Well Name: JRU APACHE FEDERAL COM	Well Location: T22S / R30E / SEC 24 / NENE / 32.383636 / -103.828916	County or Parish/State: EDDY / NM
Well Number: 710H	Type of Well: OIL WELL	Allottee or Tribe Name:
Lease Number: NMNM89051	Unit or CA Name:	Unit or CA Number:
US Well Number:	Operator: XTO PERMIAN OPERATING LLC

Type of Submission: Notice of Intent	Type of Action: APD Change
Date Sundry Submitted: 03/04/2025	Time Sundry Submitted: 02:23
Date proposed operation will begin: 03/07/2025

Procedure Description: XTO Permian Operating, LLC. respectfully requests approval to make the following changes to the approved APD. Changes to include SHL, KOP, FTP, LTP, BHL, casing design, cement program, mud circulation system and proposed total depth. FROM: TO: SHL: 441' FNL & 1028' FEL OF SECTION 24-T22S-R30E 410' FNL & 948' FEL OF SECTION 24-T22S-R30E KOP: 441' FNL & 1028' FEL OF SECTION 24-T22S-R30E 1270' FNL & 330' FEL OF SECTION 24-T22S-R30E FTP: 1580' FNL & 330' FEL OF SECTION 24-T22S-R30E 1270' FNL & 330' FEL OF SECTION 24-T22S-R30E LTP: 1580' FNL & 2540' FEL OF SECTION 23-T22S-R30E 1270' FNL & 2578' FEL OF SECTION 23-T22S-R30E BHL: 1580' FNL & 2590' FEL OF SECTION 23-T22S-R30E 1270' FNL &

[Figure F] 4 String – 2nd Intermediate casing engineered weak point

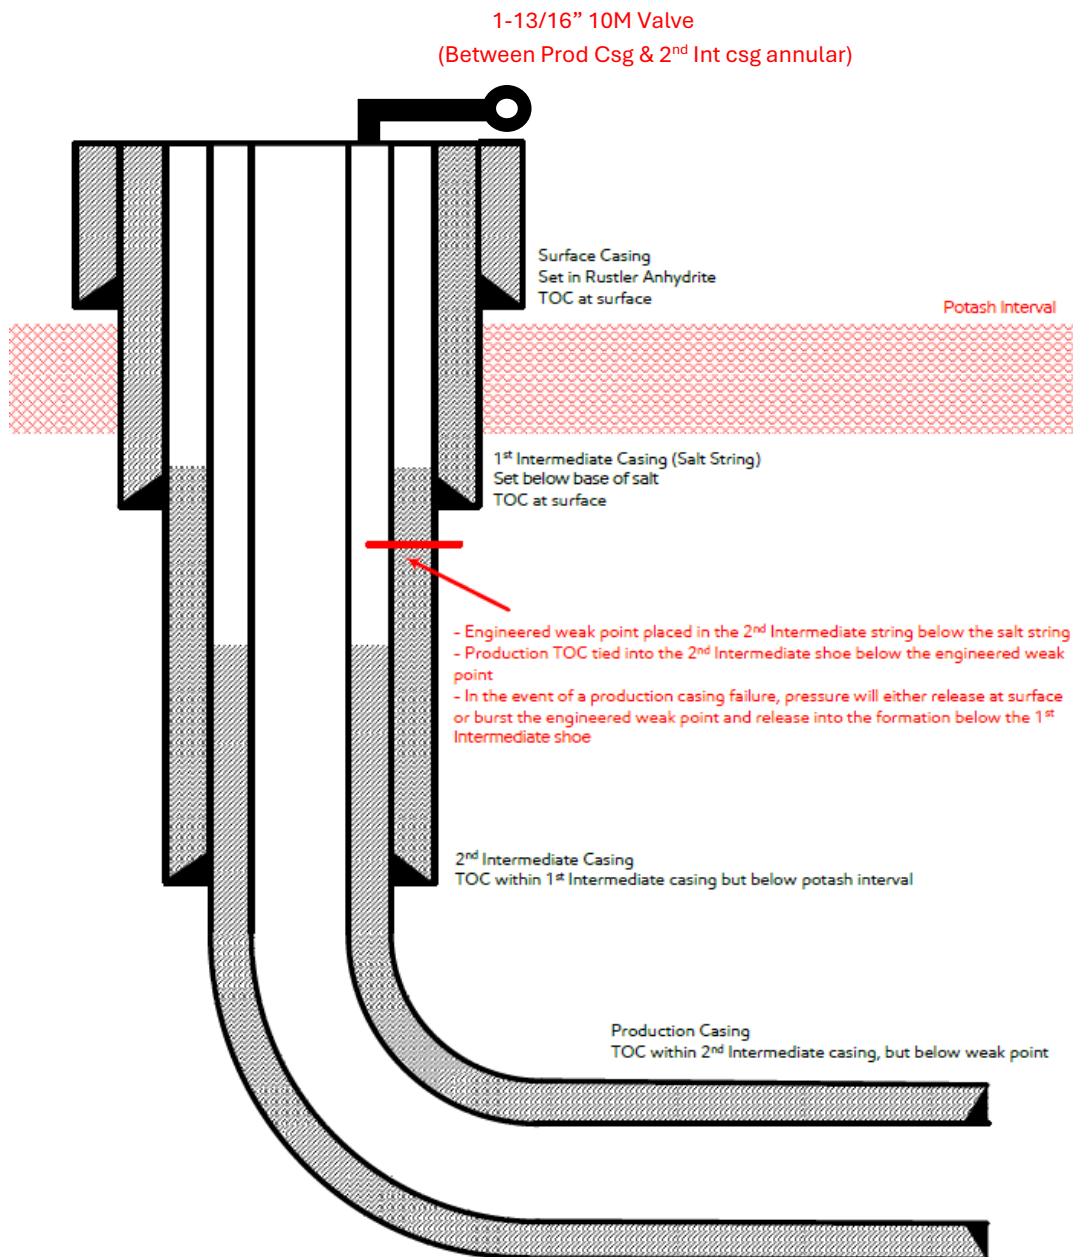
- 1) Alignment with KPLA requirements per schematic below, with engineering weak point casing design and utilizing new casing that meets API standards.
- 2) Contingency plans in place to divert fluids away from salt interval in event of production casing failure.
- 3) Intermediate 2 casing will consist of a primary cement job with TOC at the top of the Brushy Canyon formation within the Delaware Mountain Group.
 - a. Bradenhead squeeze to be completed after primary cement job to tie back TOC to intermediate 1 "Salt string" & below Marker Bed 126 "Potash Interval".
- 4) Production cement to be tied back no less than 500' inside previous casing shoe (intermediate 2 casing) and below the engineered weak point.
